NEW YORK STATE DEPARTMENT OF STATE
DIVISION OF CODE ENFORCEMENT AND ADMINISTRATION

APPLICATION FOR VARIANCE OR APPEAL

PETITION NO: 2016-0269
ROUTINE VARIANCE [ ]
BOARD VARIANCE [ ]
BOARD APPEAL [ ]
(FOR OFFICE USE ONLY)

The Rand Hall Fine Arts Library ("FAL") Project located in Ithaca, New York at Cornell University includes the continued and proposed use of the second and third floors of this existing building as a college library. Additions and modifications to the existing delineated second and third floors and the roof of the existing Rand Hall building are now proposed for the 2016 project. These modifications are the same as that submitted for Petition and Determination #2015-0432. Code drawings are included in this package as further information and use as Exhibit C.

SECTION B-B  
CODE DRAWING

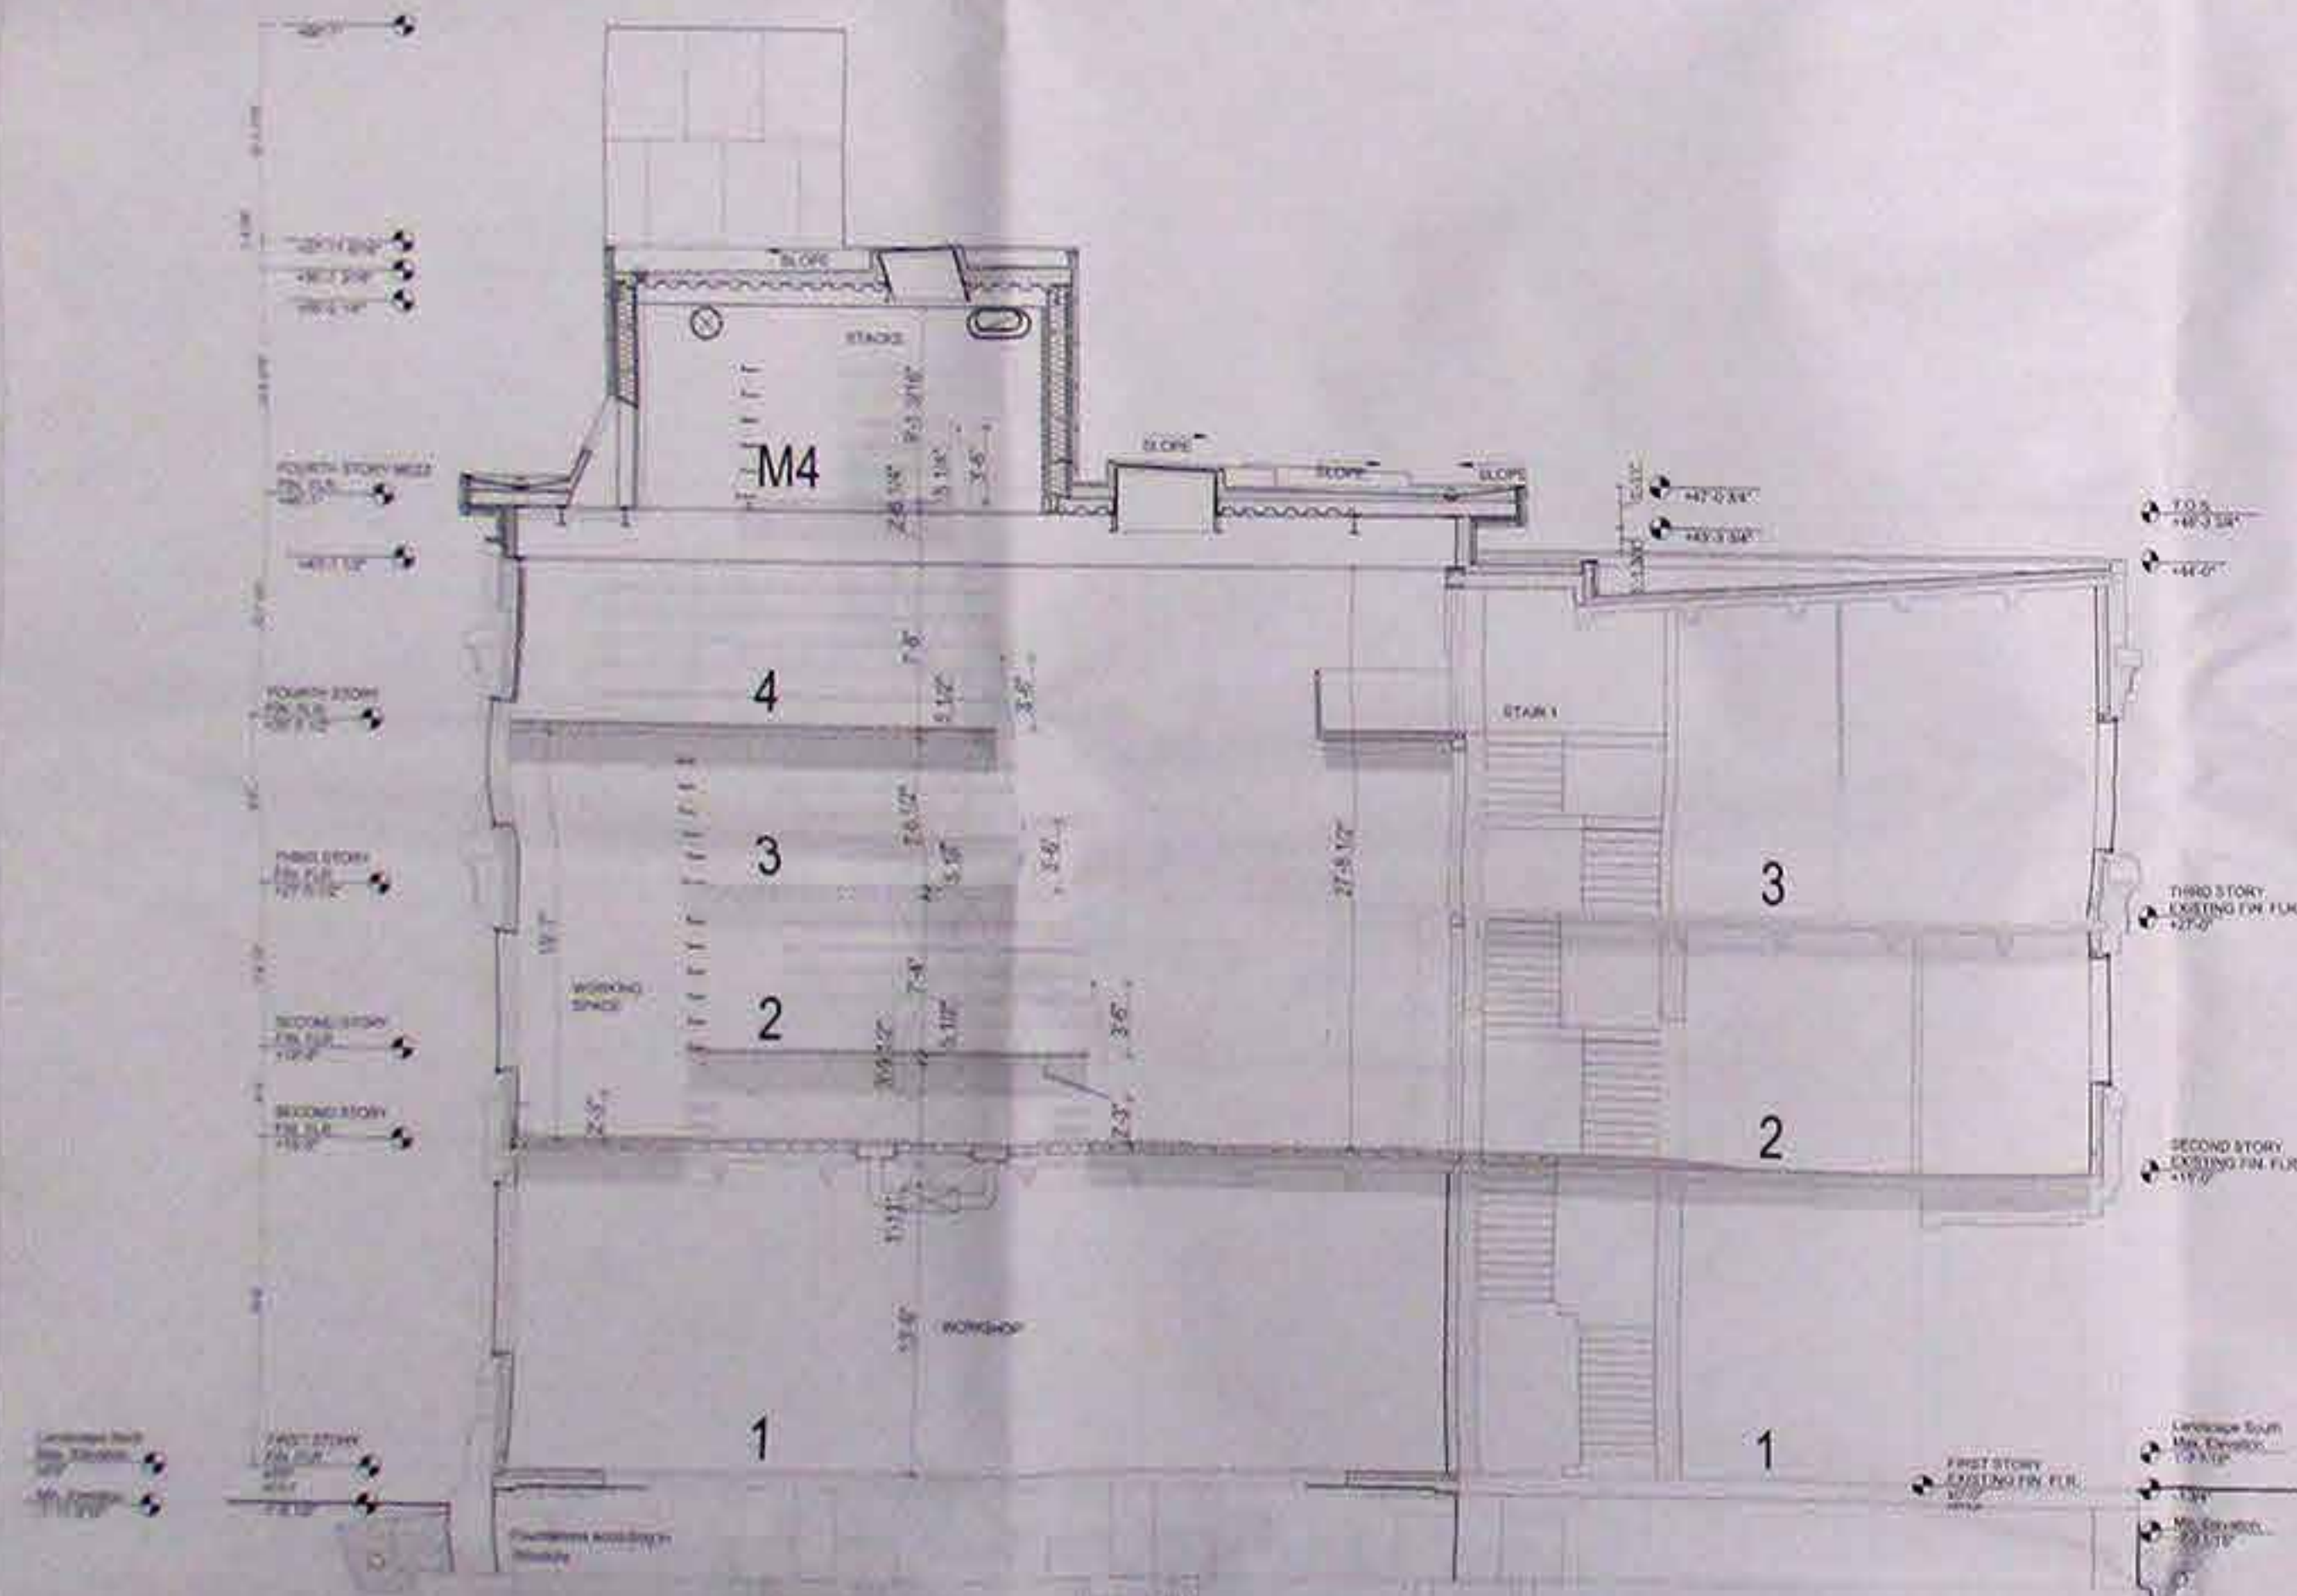
3 So in Exhibit C as in Charlie, there  
4 is a section, the drawing is entitled  
5 Section BB Code Drawing, and that's  
6 pretty much near the end. And that  
7 shows the relationships of stories and  
8 floors of what we're calling stories and  
9 such at this point. First floor being  
10 essentially at grade, second floor is  
11 the second floor, next level up is the  
12 third floor, next level up is the fourth  
13 floor. And this lantern area, which is  
14 up on top, what we're calling is the  
15 mezzanine of the fourth floor. So  
16 that's how we're dealing with that.
